# HARVATEK

## PRODUCT / PROCESS CHANGE NOTIFICATION

PCN NO:Eng-080430-01

**Change the injection mold pin position to enhance the over all reliability of the package.**

**Appendix 1 :**

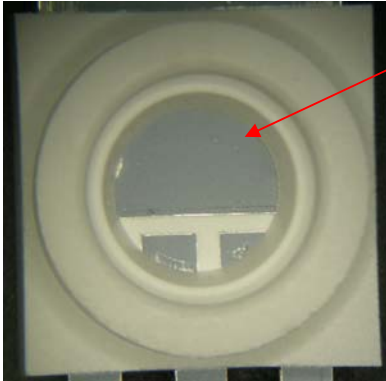
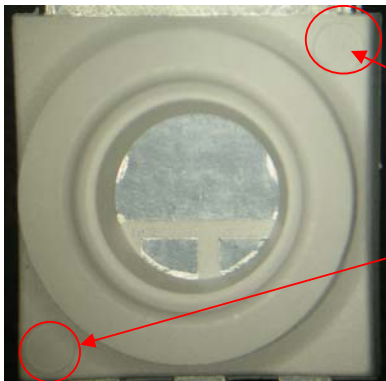
- 1. Original layout as appendix 1:injection pin in inner.**
- 2. injection pin change ,as appendix 2: in upper left & lower right increase circle mark.**

**Original injection pin position**

Injection pin in inner, effect the DA & WB  
Bond ability

**Injection pin change to outer:**

Injection pin change to outer, increase the  
DA & WB bond ability
